# COUNCIL MEETING

## MINUTES

**Monday 27 November 2023**

# North East Link Eastern Freeway Upgrades - Burke Road to Tram Road - Urban Design and Landscape Plan

**Figure 1818181818** Image of Zone 1 of Koonung Creek Reserve Draft Concept Design with annotation

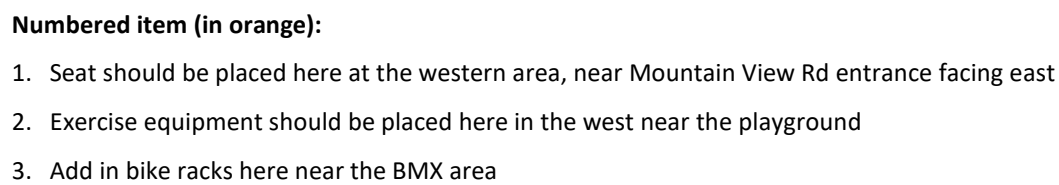
- Concerns about inundation area and if modelling has been done including the increased impermeability of the freeway and impacts of climate change.
- Desire for the exercise equipment to be retained.
- Seating should be close to the playground.
- Secondary path is good as it will provide an alternative for dog walkers than the main path.
- Supportive of the fenced off-leash dog park but concerned that this would change the off-leash status of the rest of the park.
- A participants suggested that a big and small dog parks would not work, but having some small fenced areas that dogs can use if they are overwhelmed ('dog escape rooms') would be good.
- Supportive of public toilet at Balwyn Rd.
- Some participants felt they do not need as many nature play areas plotted along the reserve; and emphasised that they should not be placed the dog park.

## 5.2 Musca Street Reserve

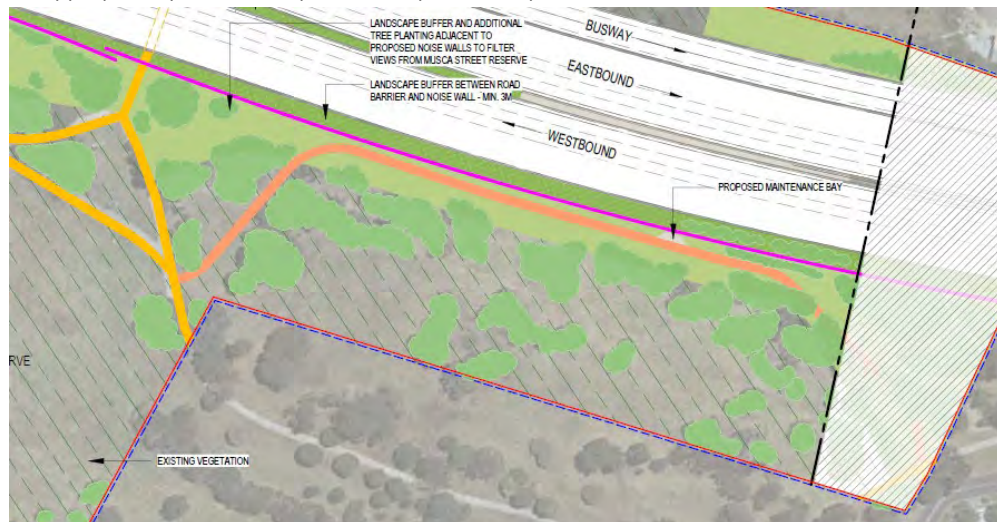
62. The encroachment of the freeway south into the open space illustrated on Landscape Drawing NO. 9536 is minimal and largely within the footprint of the existing freeway corridor. To the northwest portion of the open space, there appears to have been a gain of 2,752m<sup>2</sup> based on the difference between the existing fencing vs proposed noise wall alignment.

63. Despite this, considerable loss of vegetation is recorded along the northern edge of the reserve as per the Tree Removal & Reinstatement Plan snip below. It is understood that vegetation loss is linked to the construction of new noise walls. Given that the scale of Musca Street Reserve offers a generous buffer to residential land, it is recommended that the existing noise walls are retained if vegetation retention can be maximised.

#### Doncaster Road Underpass

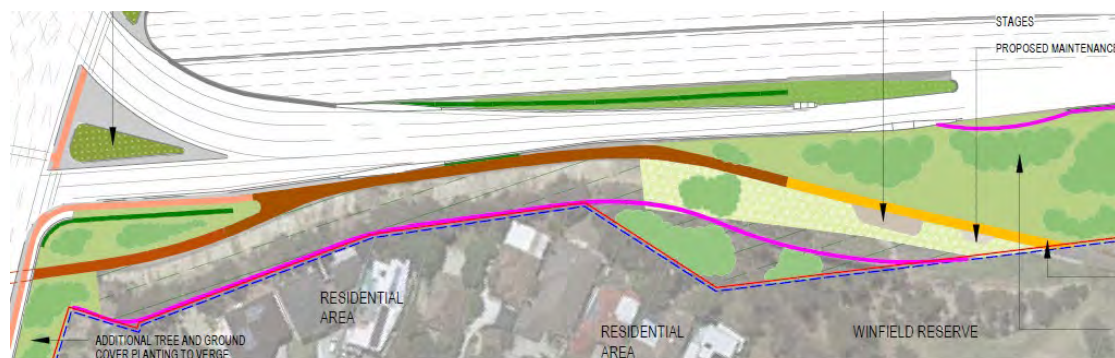
98. At the eastern edge of the reserve is the Doncaster Road underpass that is earmarked for upgrade. Proposed works are noted to include increased dimensions (to 7m wide), CPTED enhancements, functional and feature lighting and the application of brighter and textured materials to minimise darkness and the sense of enclosure.

99. The underpass upgrades appear generally positive, particularly in its widened condition and enhanced presentation through material and lighting treatments. Its 7m width would comfortably accommodate a mode separated bicycle and pedestrian path, integrated with general mode separated comments previously discussed.
